COUNCIL ASSESSMENT REPORT

Panel Reference	PPSSEC-13	
DA Number	DA.2019.086	
LGA	Burwood	
Proposed Development	Internal and external alterations to the building at 2-4 Conder Street Burwood which is currently used as Burwood Library and Community Hub, and the fitout and use of the ground floor, Level 1 and Level 2 of Building A at 8 Conder Street for use as office space by Burwood Council.	
Street Address	2-8 Conder St Burwood	
Applicant/Owner	Design Inc /Burwood Council	
Date of DA lodgement	6 September 2019	
Number of Submissions	Nil	
Recommendation	Approval subject to Conditions	
Regional Development Criteria (Schedule 4A of the EP&A Act)	Council Development with a Capital Investment Value over \$5M	
List of all relevant s79C(1)(a) matters	 Burwood Local Environmental Plan 2012 Burwood DCP Likely social, environmental and economic impacts of the development Suitability of the site for the development Submissions Public Interest

(ITEM XX/XX) DA.2019.086 – 2-8 CONDOR STREET, BURWOOD – INTERNAL AND EXTERNAL ALTERATIONS TO BURWOOD LIBRARY AND COMMUNITY HUB FOR A CUSTOMER SERVICE CENTRE – FITOUT OF LEVELS 1 AND 2 OF BUILDING A FOR COUNCIL ADMINSTRATION OFFICES AND FUTURE USE OF THE

Figure 5 Plan no. LB-LO-DA02 Library Ground Floor General Arrangement Plan

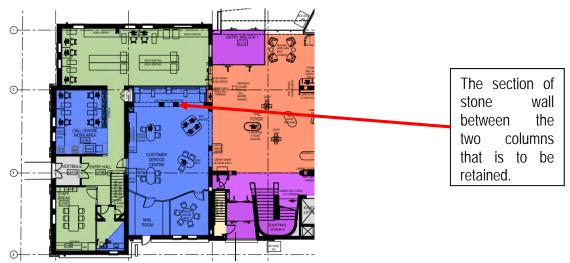
With regard to P8 and P9, there is some concern relating to the removal of much of the stone walls around the proposed Customer Service Centre on the ground floor. The use of nibs and retention of columns, ceiling bulkheads and interior details in some areas existing ceilings is a positive. Retention of more of the northern wall should be considered. The wall could also be used for an interpretation panel which should be incorporated in a public area in the building.

The retention of more of the ground floor, original stone walls should also be considered.

In relation to the retention of the ground floor original stone wall, Council's architect was advised that it would be recommended that more of the northern stone wall be retained. Council's architect has provided the following response:

"The wall extent and retention of, is something that does assist in the redevelopment of the internal space Noting we have been mindful to retain the 450mm nibs as required to ensure the existing building outline is maintained. If we are to further restrict demolition of these walls, the foyer & service centre design will simply not provide the internal flexibility and layout which is required. The entry foyer & service centre is a key aspect of the internal design of the community space. The demolition of these walls assist in accessibility which is a DDA requirement. Please note we have been mindful not remove walls unnecessarily and have in fact proposed to expose areas of original brick to further enhance the space and provide visual interest & promote conversation regarding the original heritage building which will be more visible following the proposed works. Please note the walls in question assist in movement, circulation, access to light & better suit the change management strategies being implemented in many commercial facilities which require space and openness to provide the best service.

We strongly feel that by retaining existing wall, which is plaster boarded and painted which does not clearly indicate the heritage nature of the building, be removed on the merits outlined above."

The advice from Perumal Murphy Alessi Heritage Consultants essentially recommended that more than two pillars be retained. This independent review proposed that the section of the wall between the two columns be retained as it was thought this would not affect the use of the customer service centre or seating behind. See the excerpt of plan no. *LB-LO-DA02 Library Ground Floor General Arrangement Plan* below plan for reference.

However, in light of the response provided by Council's architect, it is now considered that the retention of the small section of wall between the two pillars will prove to be cumbersome in relation to circulation space and flexibility of layout. The requirement for the Interpretation Plan, which is included as a condition of consent, will assist in detailing the history, development and significance of the building and after consideration of the comments made by Council's architect, the design of the stone wall as proposed is considered appropriate.
